**Re: SH1: Mackays to Peka Peka (M2PP), Kapiti Coast Expressway – Road Safety Review:
SH1/Otaihanga Road Intersection**

The safety audit team (SAT) for this project has been asked to carry out a further road safety review of the proposal to construct a roundabout at the existing SH1/Otaihanga Road intersection. An initial review was carried out earlier this year (see letter with comments dated 20 January 2012) following which modifications were made to the initial design. This letter/report replaces the previous safety review.

The drawings for this intersection improvement were provided at a briefing meeting at the M2PP Alliance offices in Wellington on Wednesday 7 March 2012 and are numbered CV-SP-136 (rev B) dated 24.02.12 and CV-GP-138 and 139 (both undated rev B). A site visit was undertaken in the afternoon of 7 March 2012.

Photo 1

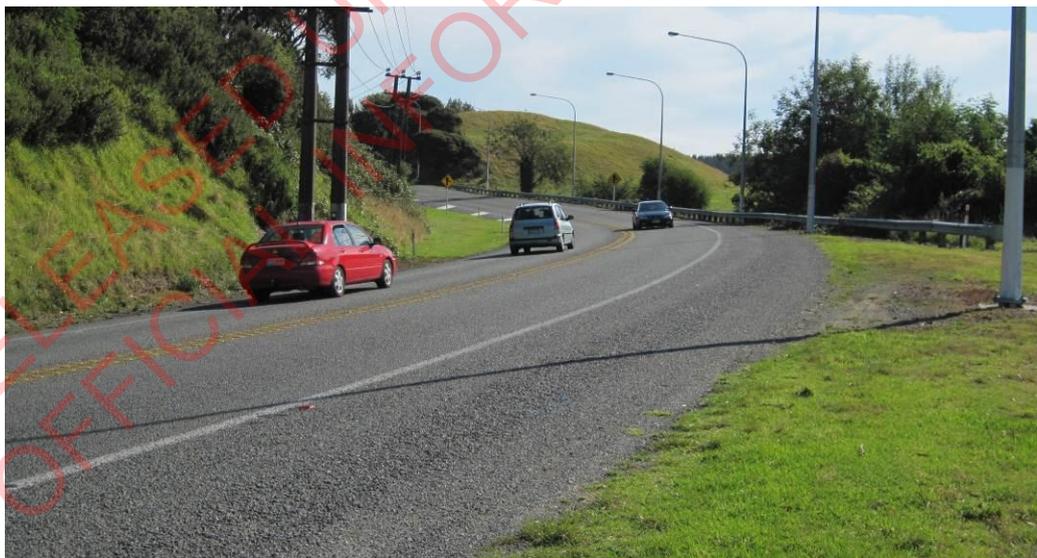
2. Approach speeds: With regard to the high speed (80 km/h) operating environment, treatment to slow vehicles prior to the roundabout will be important. The SAT endorses the use of the long splitter/median islands shown on the southbound and northbound approaches, but there will still need to be other measures such as kerbing, high impact warning signage, speed activated signs and transverse road markings considered at the detail design stage to encourage slower speeds on the approaches. Particular attention will be needed for the southbound approach from Waikanae as there is limited forward sight distance around the horizontal curve (see **Photo 1**).
